City of Beaufort Department of Planning and Development Services

MEMORANDUM

SUBJECT: Taco Bell Lighting

Taco Bell, 209 Robert Smalls Parkway

A4.1

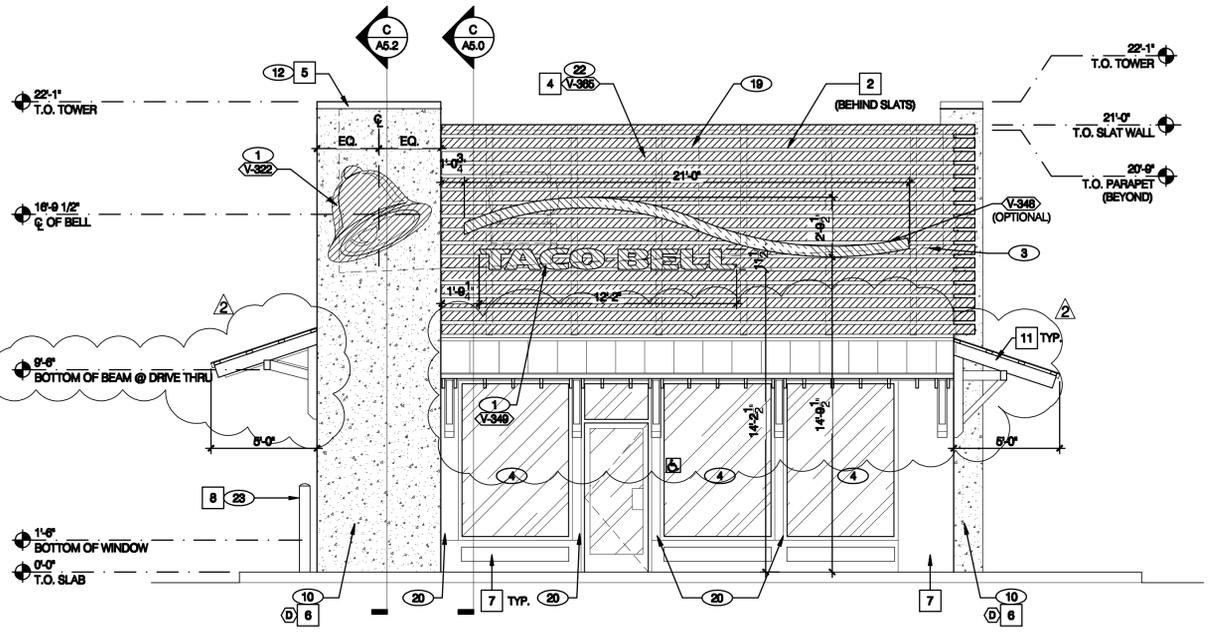
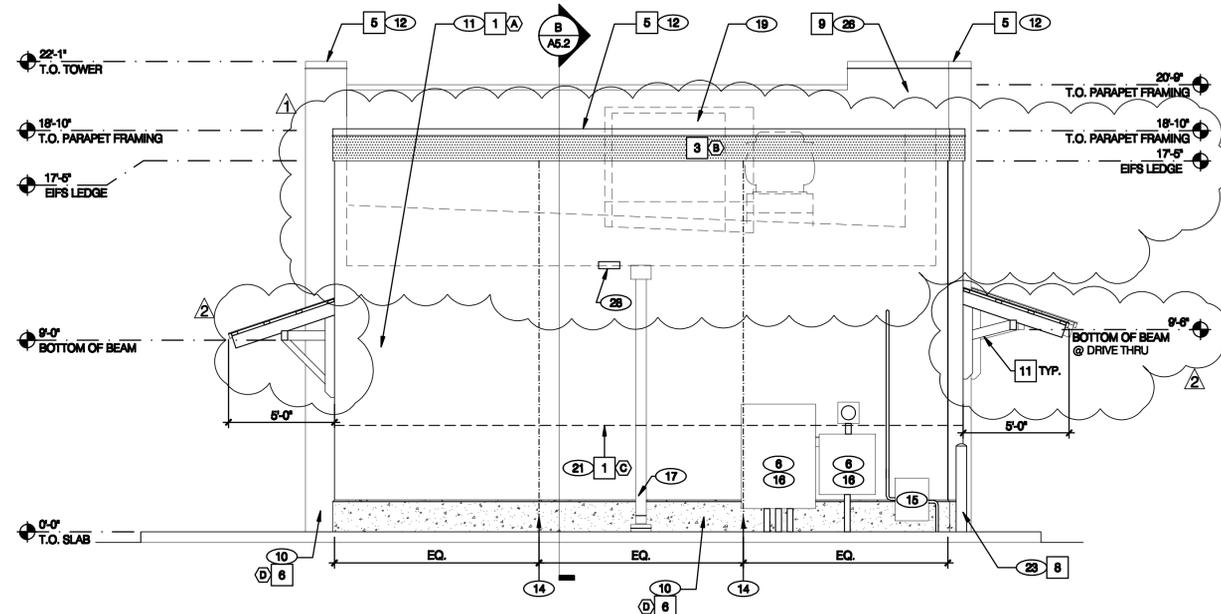
There is a metal slat wall on the main corner of the building. Behind the slat wall, the wall of the building is painted purple, Taco Bell's trademark color. In between the purple wall and the slats are LED lights. These lights were indicated on the building sections and building lighting and electrical plans (attached). However they were not indicated on any elevations, or in the photometric plan or included in the lighting cut sheets. All exterior lighting is required to be shown on the photometric plan and a cut sheet needs to be provided.

Staff asked the applicant to return to the Design Review Board to discuss this lighting, and request that the board approve the lighting retroactively. The main issue from an ordinance perspective is the fact that the lighting changes the color of the wall. Trademark colors are typically counted as signage. So it essentially makes that entire wall a sign for Taco Bell.

The lighting technique should also be considered by the board. The idea of strategic illumination of buildings, essentially turning them into beacons by using concealed internal illumination, is something that seems to be a common trend in upcoming architecture. While this may be very appropriate for architecture along highways, the Board should decide whether or not this is generally appropriate for the City of Beaufort.

- Permit the building to remain as-is;
- Request that Taco Bell could either choose to turn off the light; or
- Request that Taco Bell repaint the back a non-trademark color.

The City does have standards for the amount of lighting that can be emitted without having full-cutoff fixtures (to prevent light trespass) so if the lights are to be retained, cut sheets for the lights should be provided.
